# **MONTLAKE ELEMENTARY SCHOOL**

Certificate of Approval

Exterior Historic Stair Replacement and Revised Flag Pole Location

Revisions to the approved C of A scope for in-kind replacement of original entry stairs and modification of the proposed flagpole location.

## CONCRETE STAIR CONDITION AND CHANGE IN SCOPE FROM ORIGINAL C OF A PACKAGE:

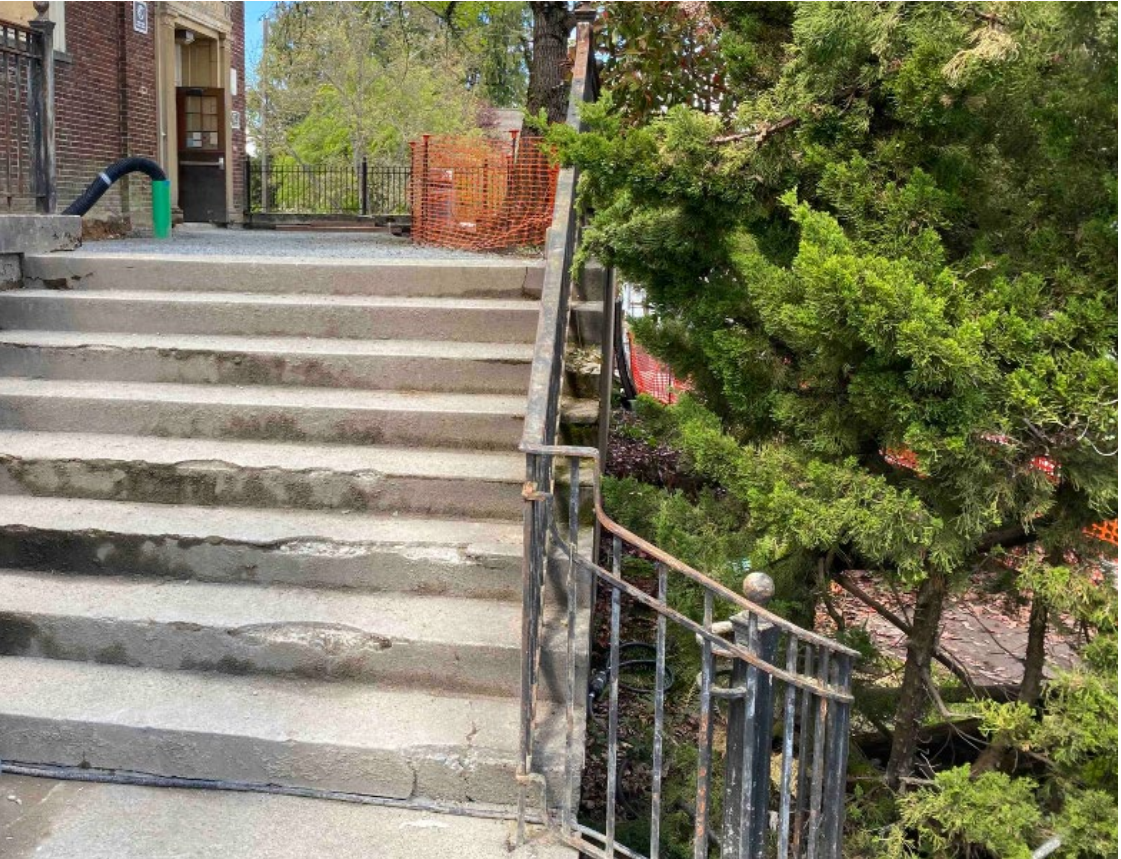
The concrete stairs were in fair condition prior to construction. Some areas of cracking and spalling were noted, but the preferred approach was to patch and repair the existing. DLR Group did note in their initial survey that these stairs had been re-surfaced in the past with a concrete topping over the original steps. The topping appeared to be holding in place for the most part with some areas of delamination noted at edges and nosings.

As construction progressed, regular foot traffic on the stairs exacerbated the delamination of the topping material. The decision was made to remove the existing stairs and replace them in-kind with new concrete steps. The existing railing was salvaged and re-installed per the details of this package and restored per the originally submitted "Metal Restoration" specifications.

# PREVIOUSLY APPROVED ENTRY FORECOURT SCOPE

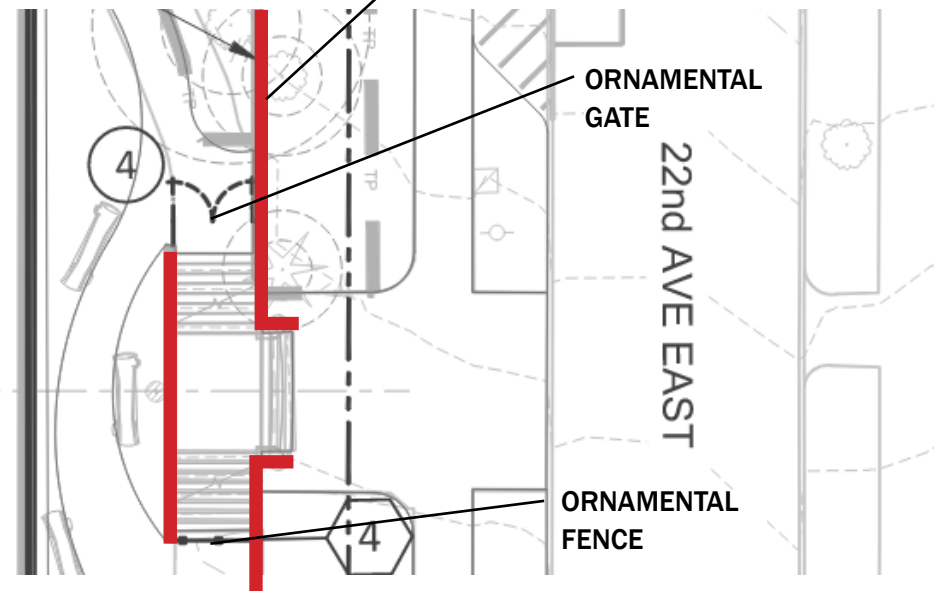
EXISTING RAILING TO BE  
CLEANED AND RE-PAINTED PER  
SUBMITTED METAL RESTORATION  
SPEC

EXISTING STAIRS TO REMAIN.  
PATCH AND REPAIR CRACKS  
PER SUBMITTED CONCRETE  
RESTORATION SPEC

Revised gate configuration and railing scope

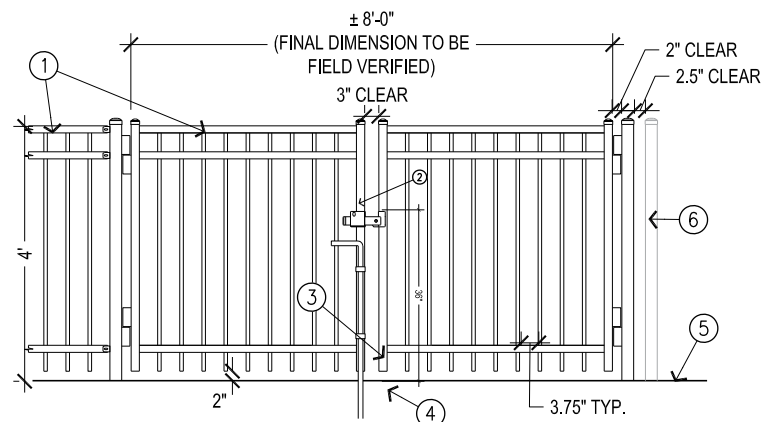
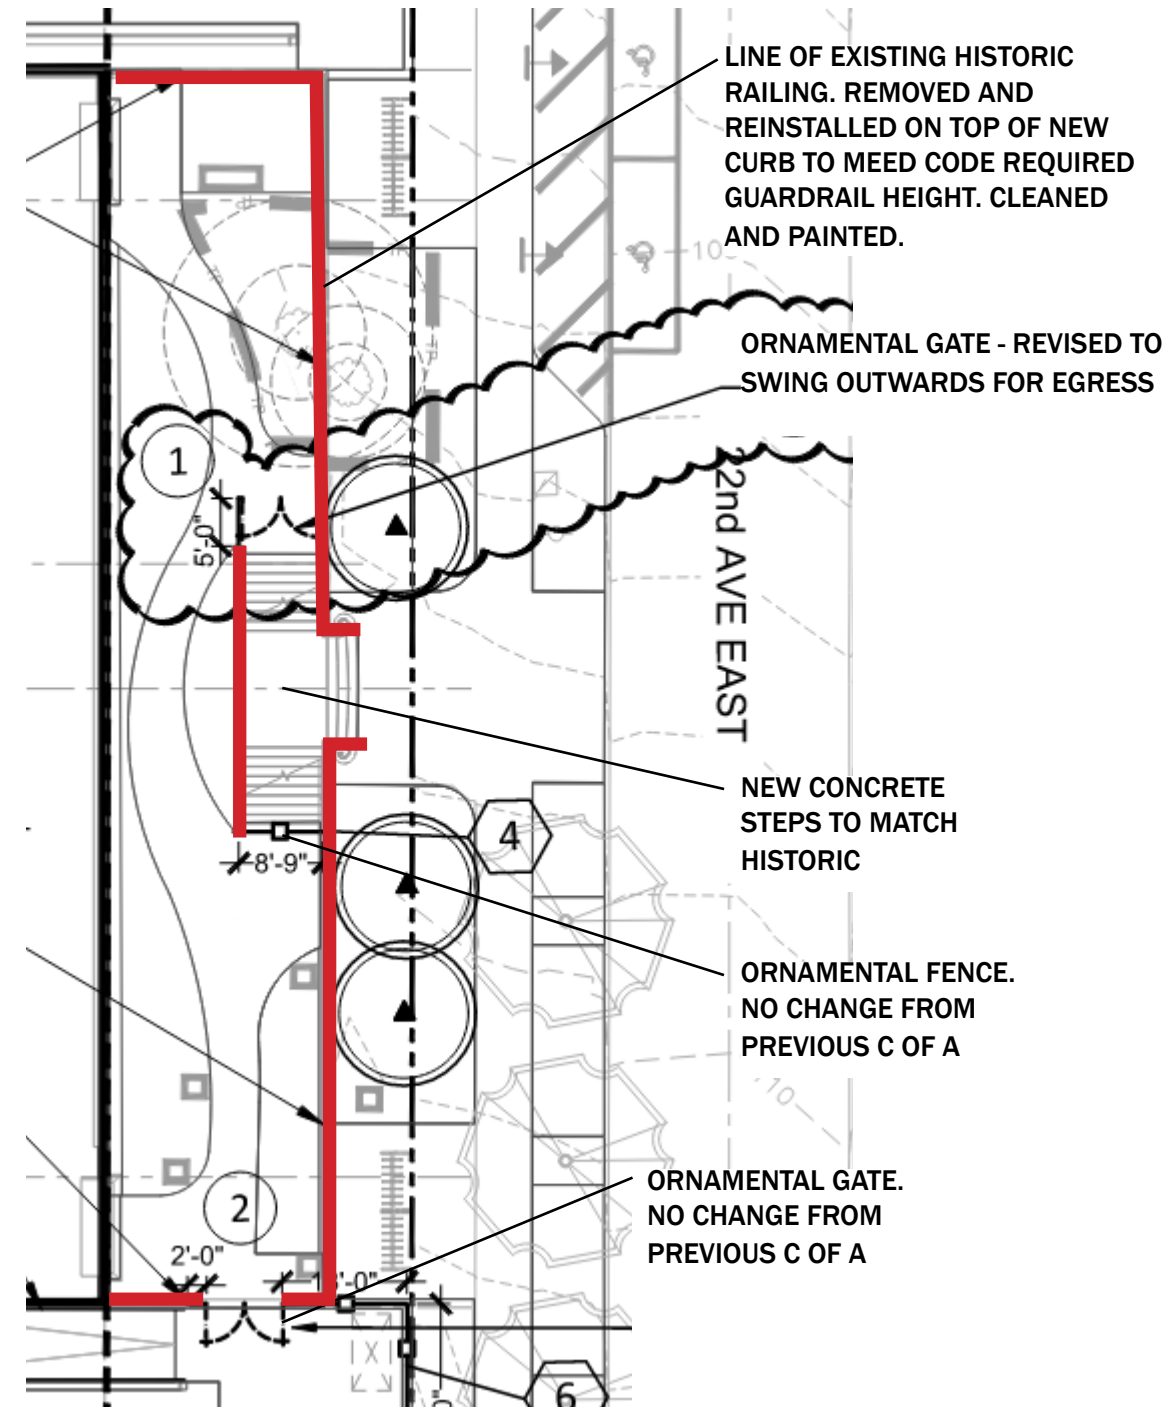
LINE OF EXISTING HISTORIC RAILING. CLEAN TO REMOVE LOOSE PAINT AND RUST. PAINT WITH RUST INHIBITIVE COATING

Proposed Ornamental gate at areas noted: Ameristar Montage II  
No change from previous C of A.
